Lindrith B Unit #75

Lindrith Gallup / Dakota West 1290' FSL & 2100' FEL / SE, Sec. 35, T25N, R3W Rio Arriba County, New Mexico

CONDITIONS OF APPROVAL FOR PERMANENT ABANDONMENT

Operator Conoco Inc. Well Name #75 Lindrith B Unit

Proposed P&A

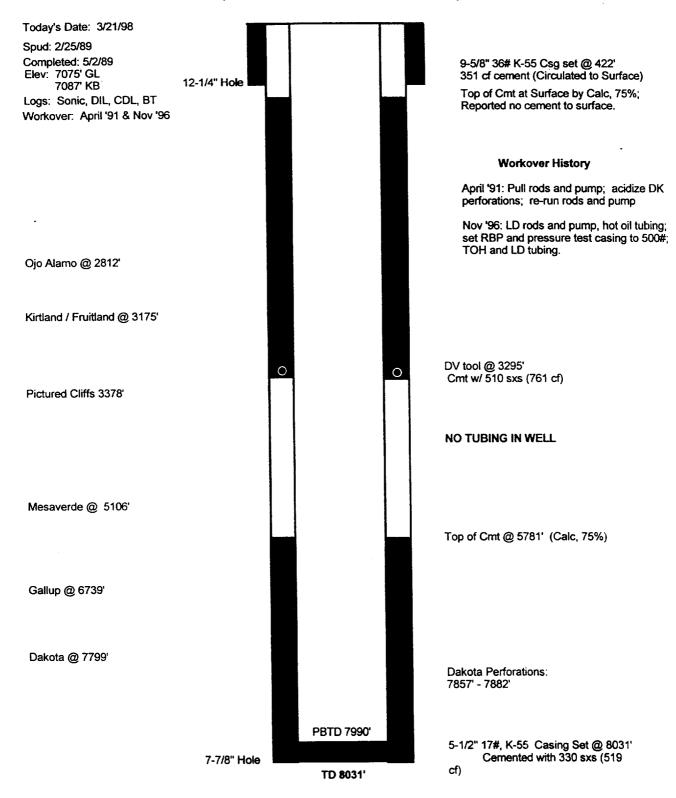
The Nacimento Formation needs to have a cement plug. Nacimento top is at 1500 feet, TOC (from Sundry Notice 5/5/89) is at 2720 feet. Procedures and cement volumes used for Plug #3 will be used for this plug.
